HISTORIC AND DESIGN REVIEW COMMISSION

October 04, 2023

HDRC CASE NO: 2023-321
ADDRESS: 327 E KINGS HWY
LEGAL DESCRIPTION: NCB 6327 BLK 2 LOT 50
ZONING: R-5, H
CITY COUNCIL DIST.: 1
DISTRICT: Monte Vista Historic District
APPLICANT: Oscar Flores/Oscar Flores Design Studio
OWNER: Patrick Moloney/MALONEY JOHN PATRICK JR
TYPE OF WORK: New construction of a 2-story single-family structure and a 1-story rear accessory structure
APPLICATION RECEIVED: September 15, 2023
60-DAY REVIEW: November 14, 2023
CASE MANAGER: Rachel Rettaliata

The applicant is requesting a Certificate of Appropriateness for approval to construct one 2-story, single-family structure and one 1-story detached garage at 327 E Kings Hwy.

SHEET TITLE
SITEPLAN

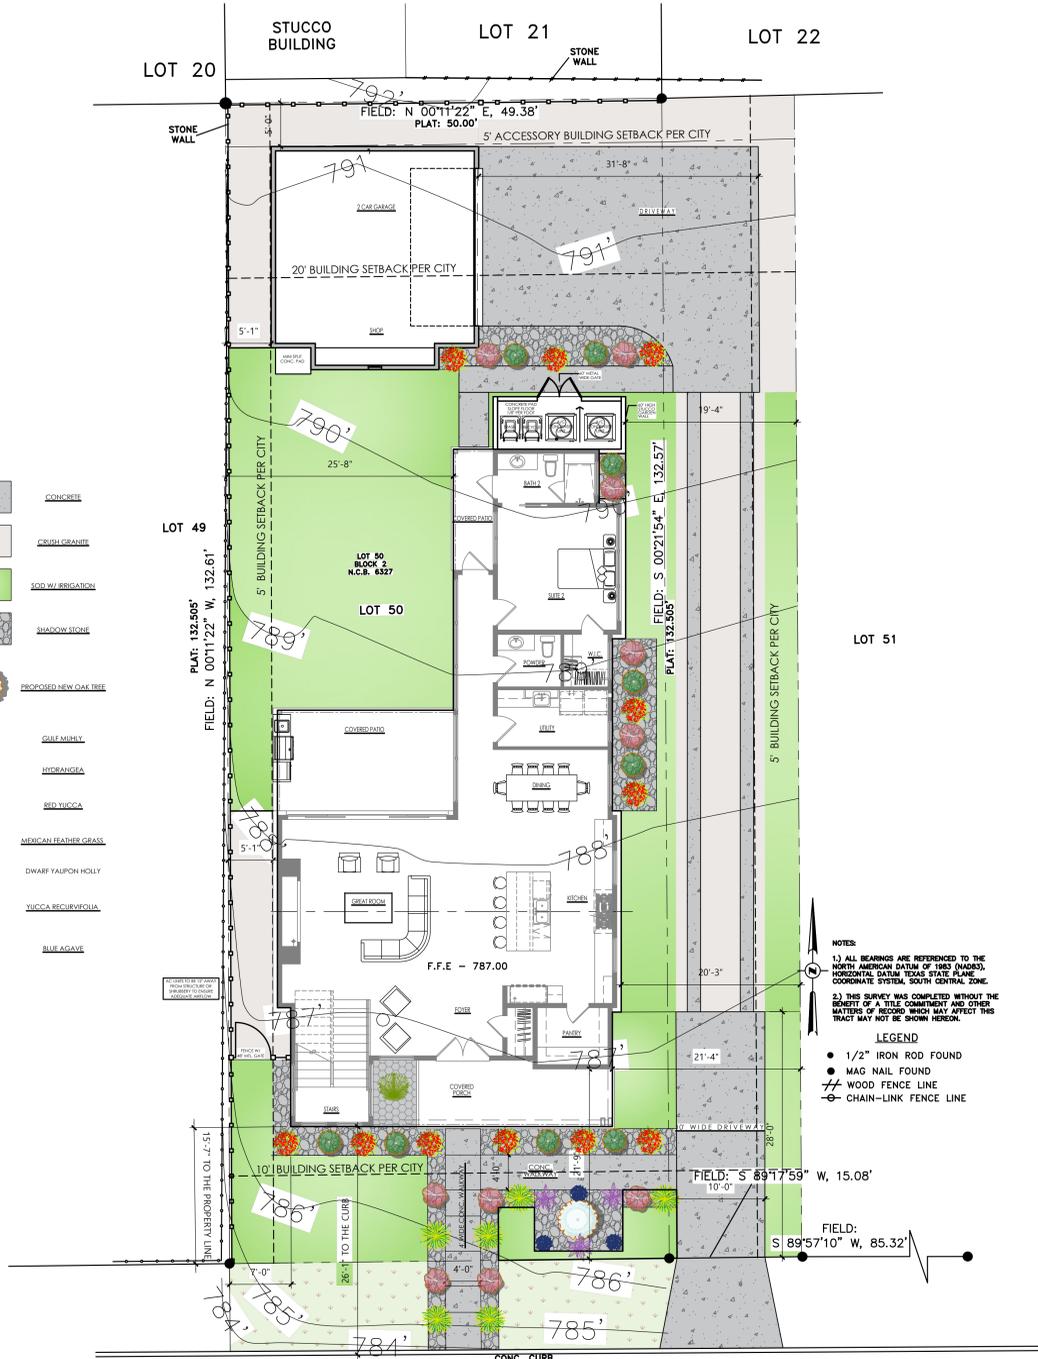
Refer to sheet A.3 – Site plan indicating setbacks per UDC Sec. 35-310-1 table, 35-310.05, 35-370 (b)

SHEET TITLE
LANDSCAPE PLAN
&
SETBACK DIAGRAM

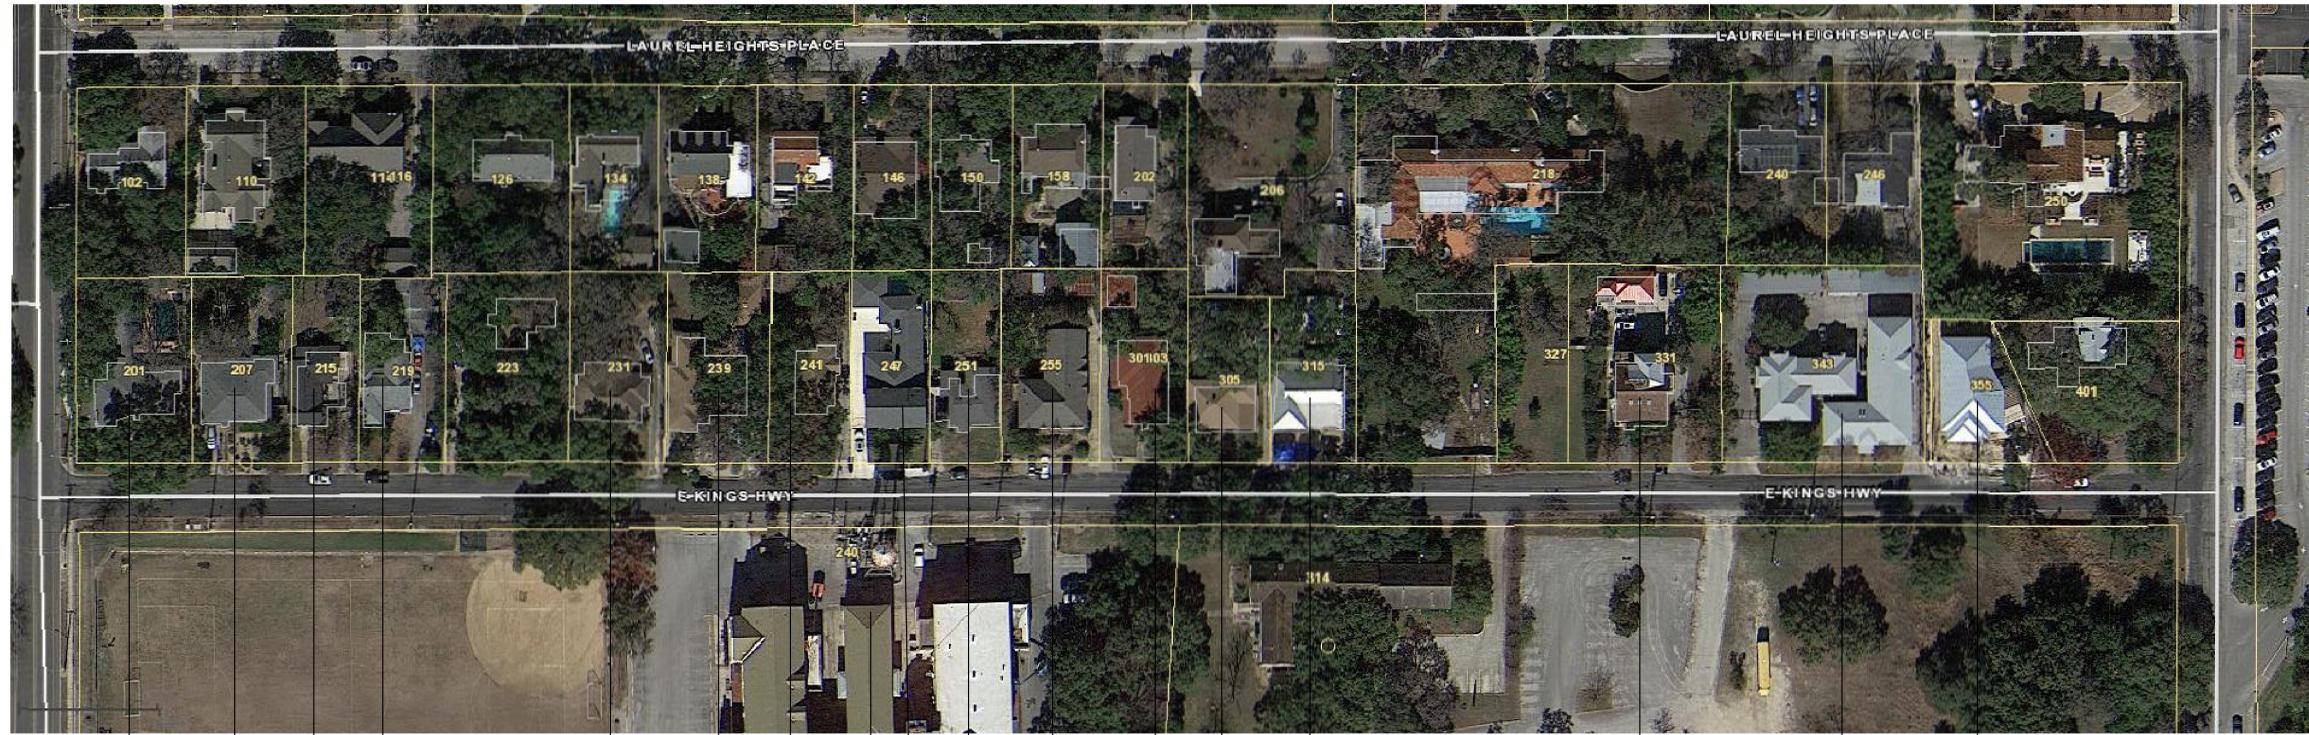
Refer to sheet A.4 – Landscape plan for front and rear of property showing installation of native plants and hardscape.

A.5
SHEET OF 12

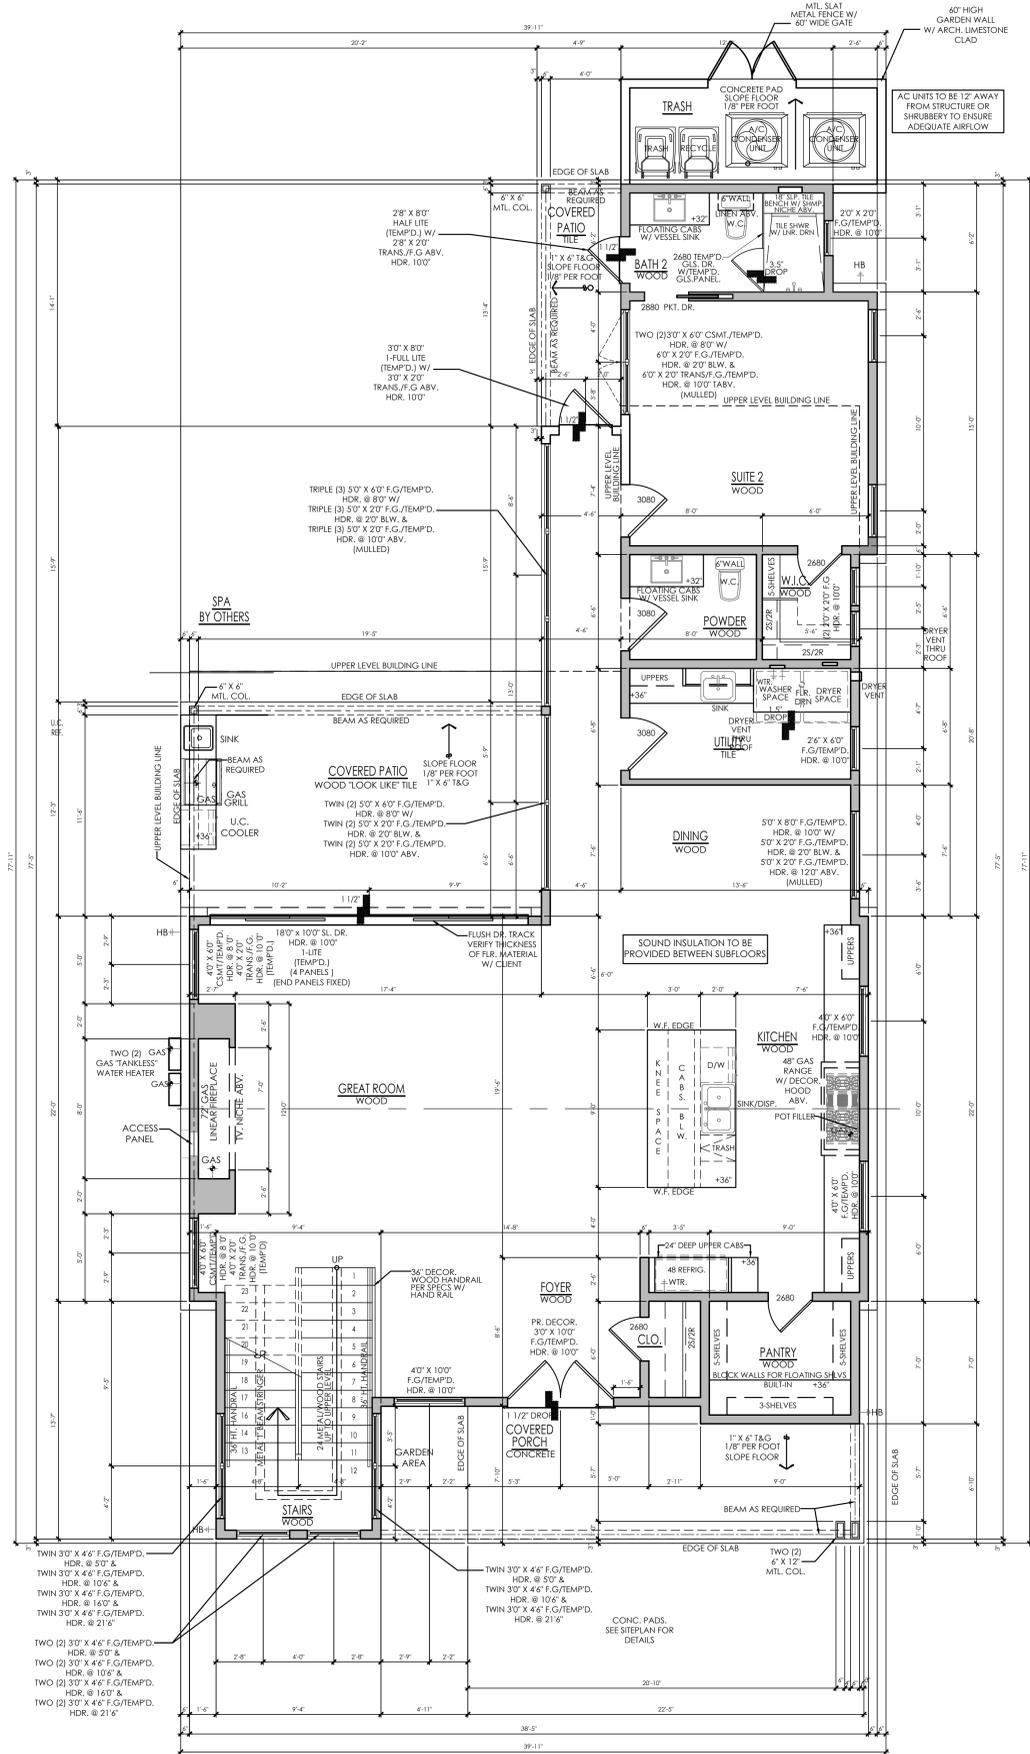
Ref: to sheet A.5. – Diagram has previously shown and is showing the information required.

SHEET TITLE
RIGHT & LEFT SIDE ELEVATIONS

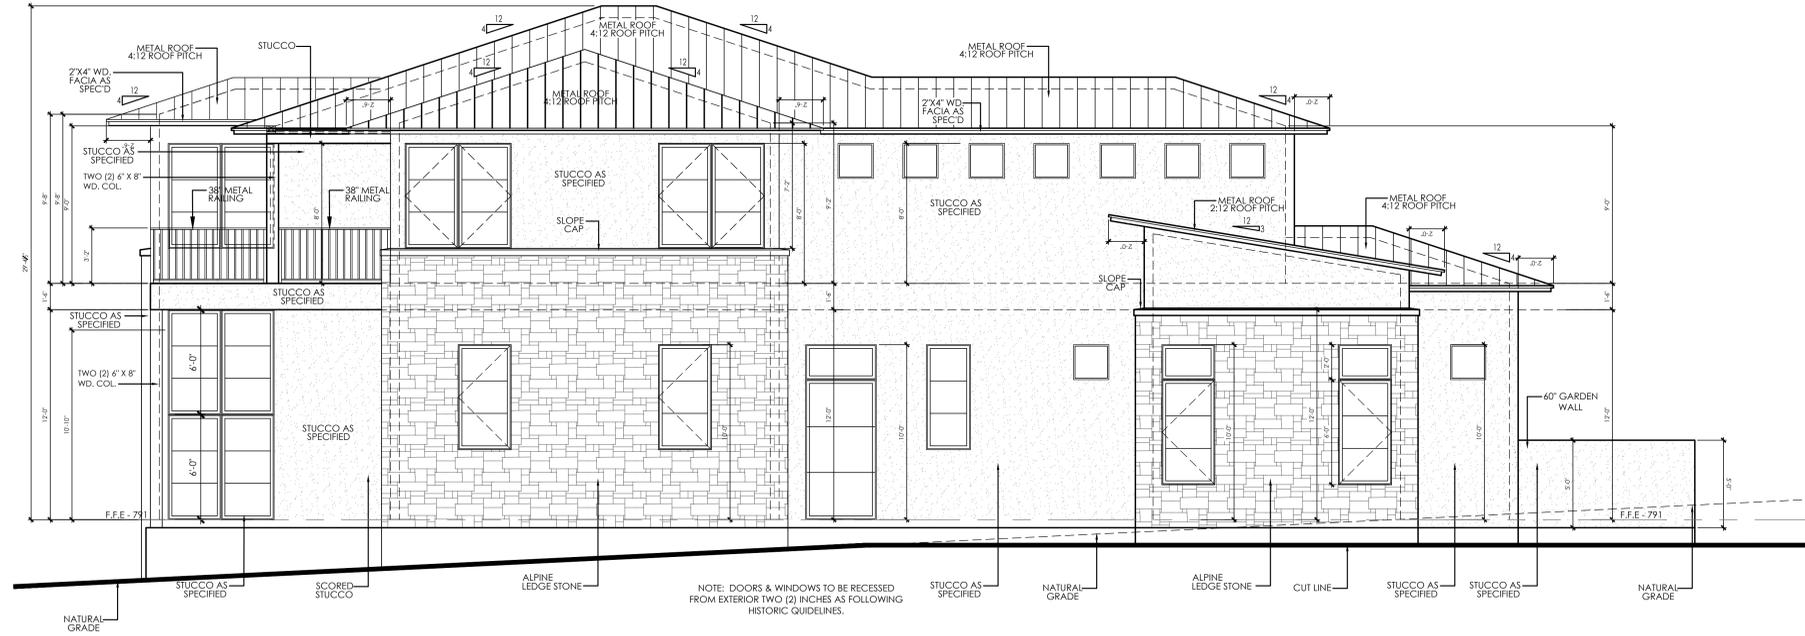
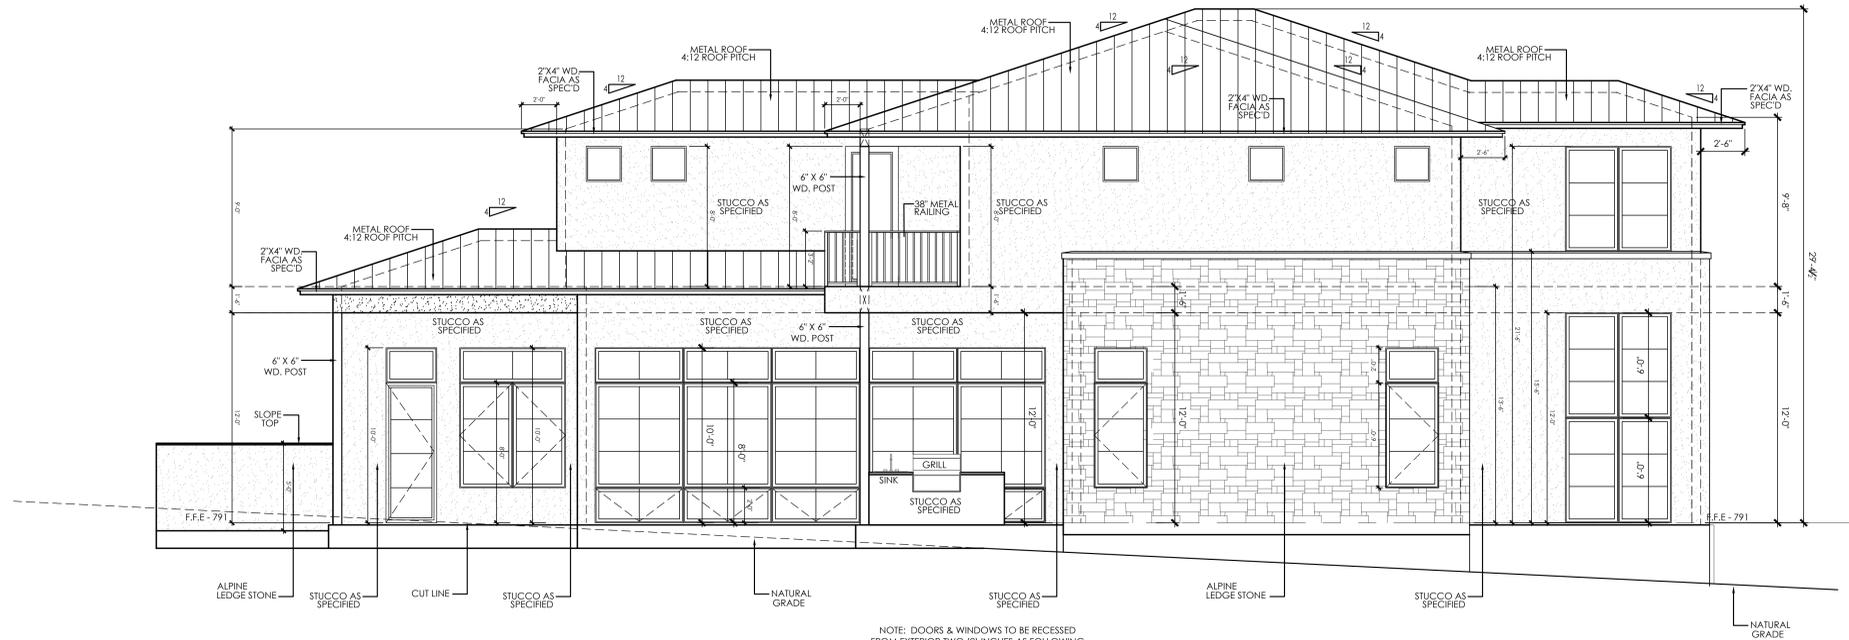
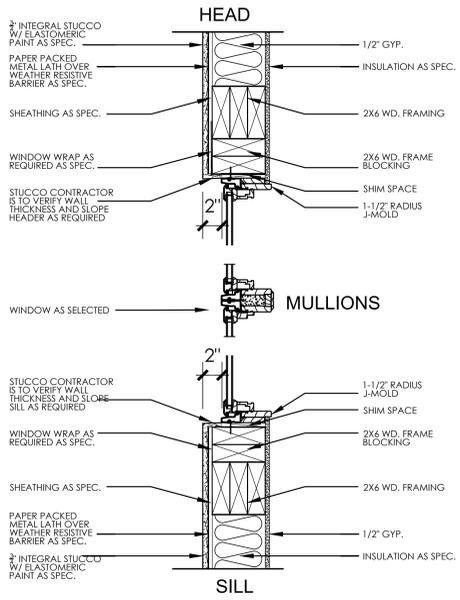
Ref: to sheet A.9 & A10. Exterior elevations indicate material type and location.

Refer to sheet A.9 & A.10 – Header and Sill Detail.

Refer to sheet A.9 & A.10 – Header and Sill Detail.

Refer to Sheet A.9 & A.10 – Front elevation show change of staircase design from previous design. The change was made with Monte Vistas ARC suggestions and approval from the last meeting. In the last HDRC meeting this was not brought up as an issue. Comments consisted in adjusting side elevation fenestrations which we have addressed. We have included an example of bay windows that are larger than what we have proposed and that is located at 250 Laurel Heights Pl.
